**LAND NORTHEAST OF M1
JUNCTION 22,
MARKFIELD,
LEICESTERSHIRE**

**WHITWICK ROAD/A50
WESTBOUND SLIP ROAD**

**UPDATED STAGE 1
ROAD SAFETY AUDIT REPORT**

**REQUESTED BY:
RIDGE AND PARTNERS LLP**

TITLE
A50 WESTBOUND OFF-SLIP
CROSSING VISIBILITY SPLAYS

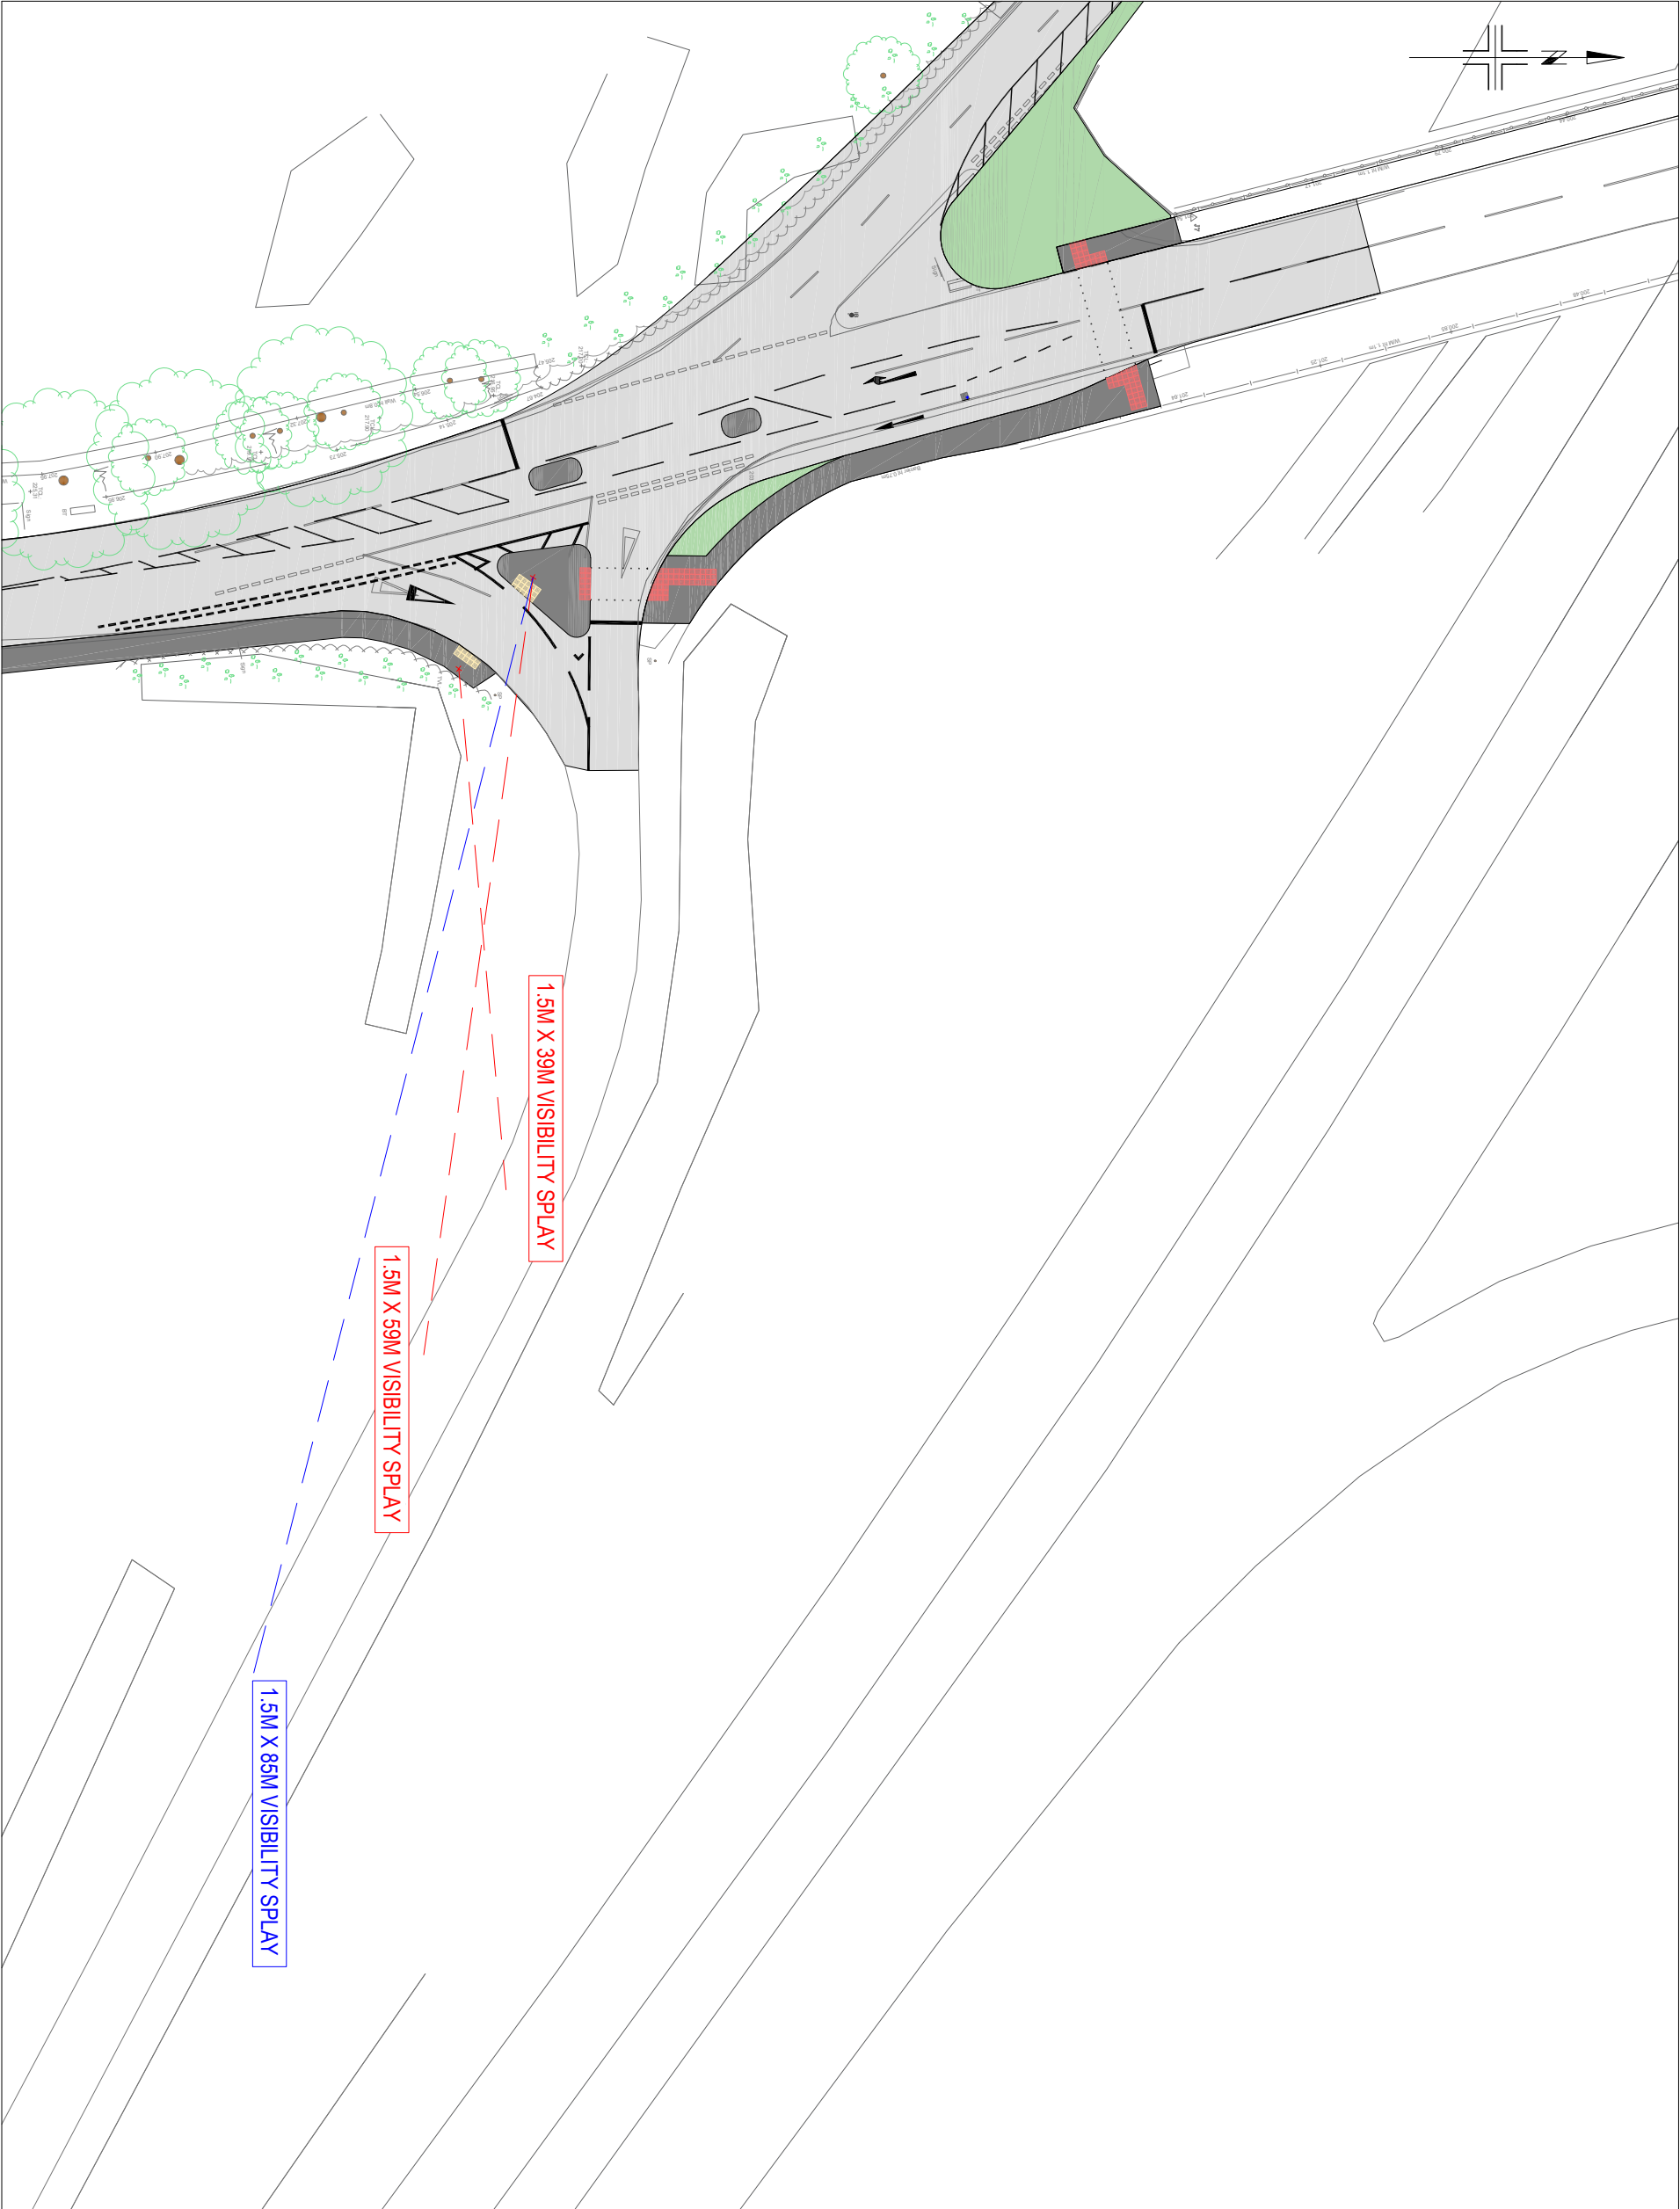
There is concern that the no details in relation to the visibility splays to and from the proposed tactile landings at the uncontrolled crossing facility across A50 westbound off slip have been provided. Poor visibility for pedestrians using the crossing may encourage them to step out onto the carriageway to observe oncoming vehicles which may increase the risk of them being struck by turning vehicles.

2.6	There is concern that the no details in relation to the visibility splays to and from the proposed tactile landings at the uncontrolled crossing facility across A50 westbound off slip have been provided. Poor visibility for pedestrians using the crossing may encourage them to step out onto the carriageway to observe oncoming vehicles which may increase the risk of them being struck by turning vehicles.	Review the layout to ensure visibility splays to and from the tactile landings are provided any obstructions in the visibility should be removed.	Partly accepted. The visibility splays from 1.5m back from the kerb line has been shown on Drawing T22523.011. For pedestrians waiting on the southern side of the crossing, a 1.5m x 39m visibility splay can be achieved (equivalent to 28mph design speed), which would result in an improvement on the existing situation with some vegetation within the highway boundary being cut back. For pedestrians waiting on the proposed refuge island, a 1.5m x 59m visibility splay could be achieved, equivalent to 37.5mph; allowing for the existing give way sign setback 60 yards from the junction. If this sign was relocated, a 1.5m x 85m visibility splay could be achieved as shown in Drawing T22523.011. Given that vehicles will be slowing down on approach to the junction, the visibility splays are considered to be appropriate. Where required, the vegetation, which is located within the public highway, will be cut back as part of the s278 works to achieve this splay and maintained by LCC as the LHA thereafter.

Review the layout to ensure visibility splays to and from the tactile landings are provided any obstructions in the visibility should be removed.
